City of Ottawa
Development Review Branch
Grading & Servicing Reviewed
Name: Bruce Bramah, EIT
Signed:
Date: 12/30/2020

Telephone # 723-9227
Plan # 4M- 1617
Project name: PATHWAYS
Civic Address: 15 SALAMANDER WAY
House model: ANNAPOLIS 'E'

LOT 22 SITE/GRADING PLAN
PATHWAYS

INDIVIDUAL LOT GRADING REVIEW SUMMARY FOR SITED HOUSE AS COMPARED WITH OVERALL SUBDIVISION PLAN

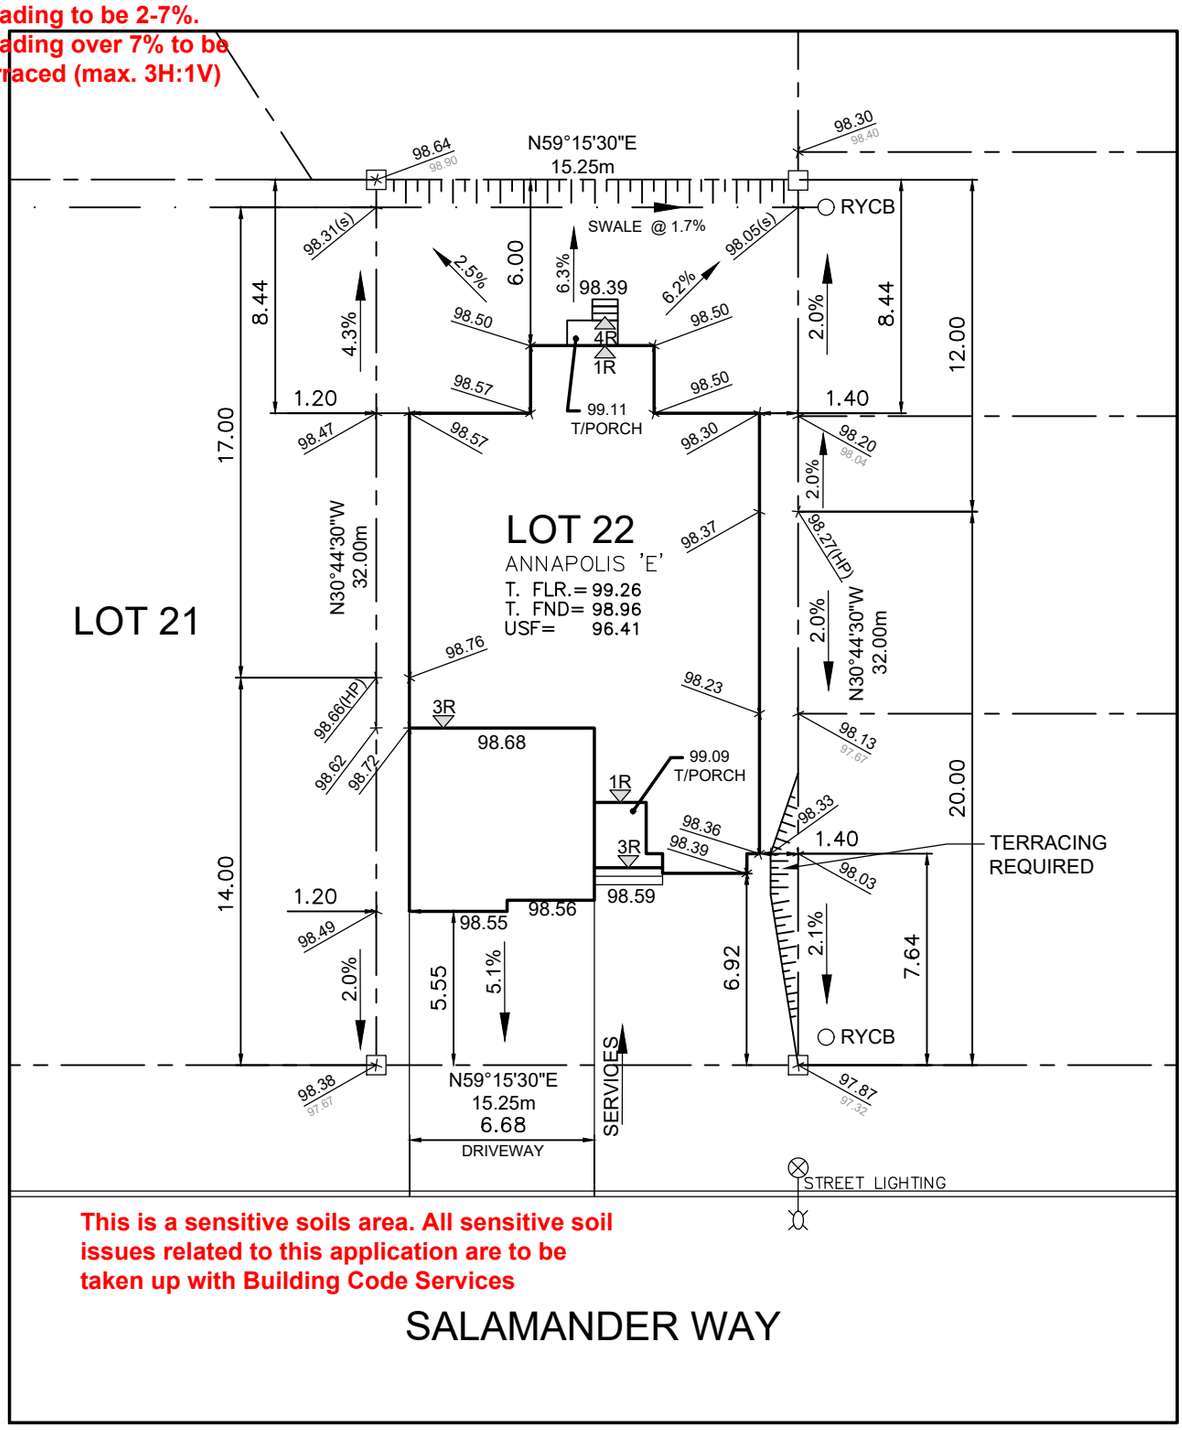
Sleeved services required under retaining walls / footings / garage, and are recommended under porches, decks, and similar structures

No excess drainage to be directed towards adjacent properties
Existing grading and drainage patterns must not be altered
Match existing elevations with abutting properties
Grading to be 2-7%.
Grading over 7% to be terraced (max. 3H:1V)

This is a sensitive soils area. All sensitive soil issues related to this application are to be taken up with Building Code Services
